Access Compliance Report Public Rights-of-Way (Curb Ramps)

Main Street: DOWNING_ST Cross Street: TUDOR_WAY Location: N

ADA ID: RPAT211103131311 Ramp Type: Type 4 - Parallel Initial Pass/Fail: Fail Overall Compliance: No Severity Score: 15

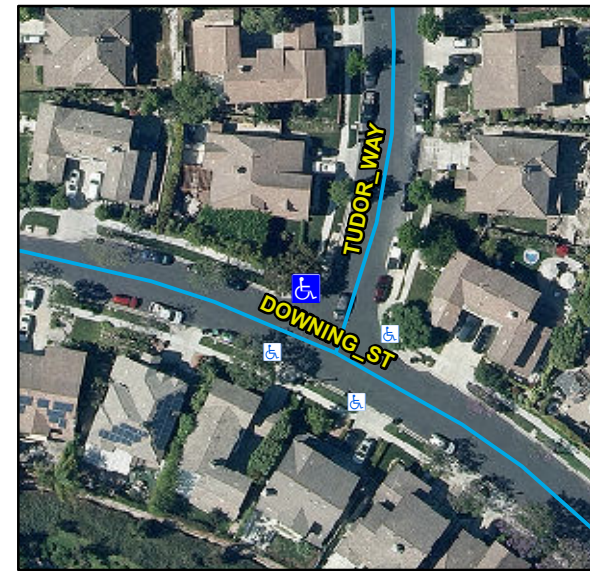
Compliance	Description	Data	Compliance	Description	Data
N/A	Ramp Length LT (in)	63	N/A	Ramp Length RT (in)	93
Yes	Ramp Width LT (in)	49	Yes	Ramp Width RT (in)	49
Yes	Ramp Run Slope LT (%)	4.1	Yes	Ramp Run Slope RT (%)	7.4
No	Ramp Cross Slope LT (%)	5.3	Yes	Ramp Cross Slope RT (%)	0.5
N/A	Landing Present	N/A	N/A	DWS Provided	N/A
N/A	Landing Length (in)	N/A	N/A	DWS Contrast	N/A
N/A	Landing Width (in)	N/A	N/A	DWS Length (in)	N/A
N/A	Landing Run Slope (%)	N/A	N/A	DWS Full Width	N/A
N/A	Landing Cross Slope (%)	N/A		DWS Offset Type	N/A
N/A	Landing Movement Obstructed?	N/A	N/A	DWS Offset Left (in)	N/A
	Landing Movement Type	N/A	N/A	DWS Offset Right (in)	N/A
N/A	Landing Shared	N/A			
N/A	Clear Space	Yes			
N/A	Clear Space To Crosswalk (in)	N/A			
N/A	Marked Crosswalk 1	No	N/A	Marked Crosswalk 2	No
	Crossing 1 Direction	SW		Crossing 2 Direction	SE
	Marked Crosswalk 1 Width (in)	N/A		Marked Crosswalk 2 Width (in)	N/A

N/A	Ramp Inside Crosswalk 1	N/A	N/A	Ramp Inside Crosswalk 2	N/A
	Crossing 1 Slope (%)	0.9		Crossing 2 Slope (%)	1.7
	Crossing 1 Cross Slope (%)	2.1		Crossing 2 Cross Slope (%)	0.3
N/A	Gutter Ponding	N/A	No	Curb Slope	12.8
Yes	Gutter Lip Height (in)	0		Road Run Slope (%)	1.3
N/A	Gutter Run Slope (%)	N/A		Road Cross Slope (%)	2.2
N/A	Gutter Cross Slope (%)	N/A	No	Perpendicular Joint Present	No
Yes	Overall Surface Condition	Acceptable			
	Cross Gutter Present?	No		Spandrel Present?	No
	Replace Cross Gutter?	N/A		Replace Spandrel?	N/A

Remove & Replace Curb Ramp With Two New Directional Ramps or Equivalent.
